SPRINGHILL COMMERCIAL PARK SUBDIVISION, **UNIT THREE, RESUBDIVISION OF**

APPLICATION NUMBER 20 DATE November 15, 2007

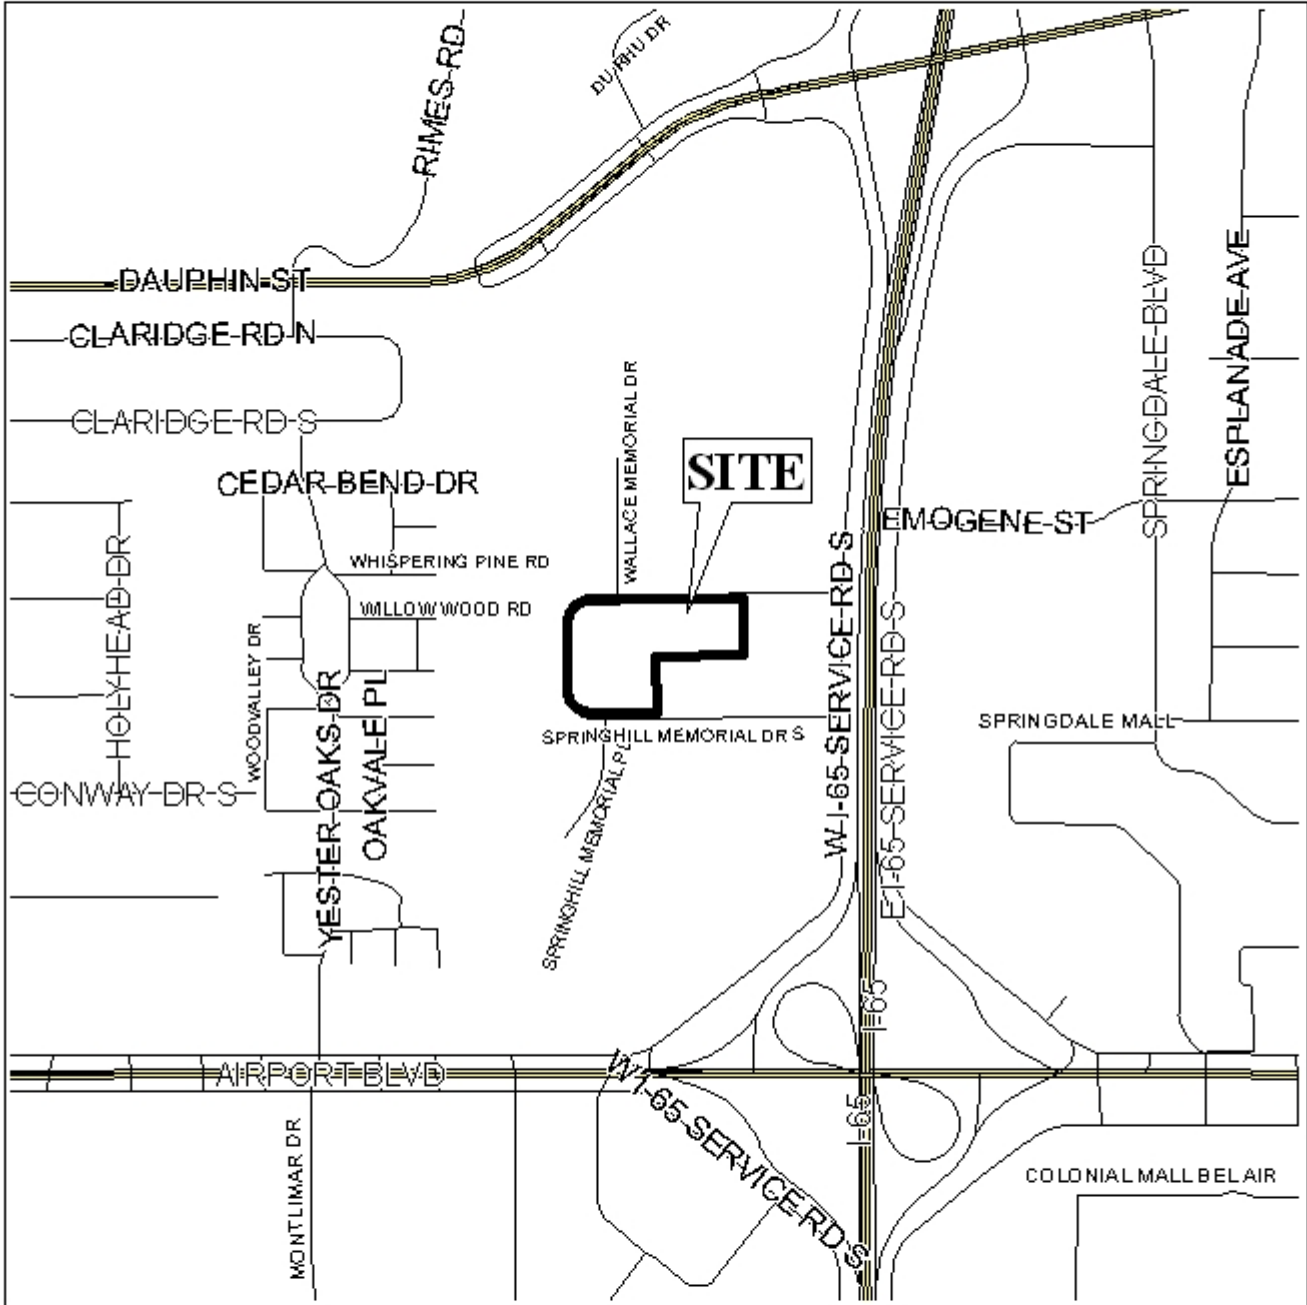
The plat illustrates the proposed 6.4± acres, two lot subdivision, which is located on the East side of Springhill Memorial Drive West, extending from Springhill Memorial Drive North to Springhill Memorial Drive South, in city council district 5. The subdivision is served by city water and sanitary facilities.

The site fronts Springhill Memorial Drive North, Springhill Memorial Drive West, and Springhill Memorial Drive South, all with adequate 50' rights-of-way. Lot A would have frontage on Springhill Memorial Drive North only, and should be limited to two curb cuts, with the size, location and design to be approved by Traffic Engineering and conform to AASHTO standard. Lot B would have frontage on all three streets; as a means of access management, Lot B should be limited to two curb cuts to each street, subject to the same Traffic Engineering approvals as Lot A. The plat did not illustrate a minimum building setback line; therefore, a 25' minimum building setback line should be illustrated along all street frontages.

The proposed lots are not labeled with their size in square feet; therefore, the lots should be labeled with their size in square feet, or a table should be provided on the final plat indicating the same information.

- 1) placement of a note on the final plat stating that Lot A is limited to two curb cuts to Springhill Memorial Drive North, with the size, location, and design of all curb cuts to be approved by Traffic Engineering and conform to AASHTO standards;

- 2) placement of a note on the final plat stating that Lot B is limited to two curb cuts to each Springhill Memorial Drive North, Springhill Memorial Drive West, and Springhill Memorial Drive South, with the size, location, and design of all curb cuts to be approved by Traffic Engineering and conform to AASHTO standards;

- 3) illustration of a 25' minimum building setback line along all street frontages;
- 4) labeling of each lot with its size in square feet, or the provision of a table on the final plat with the same information;
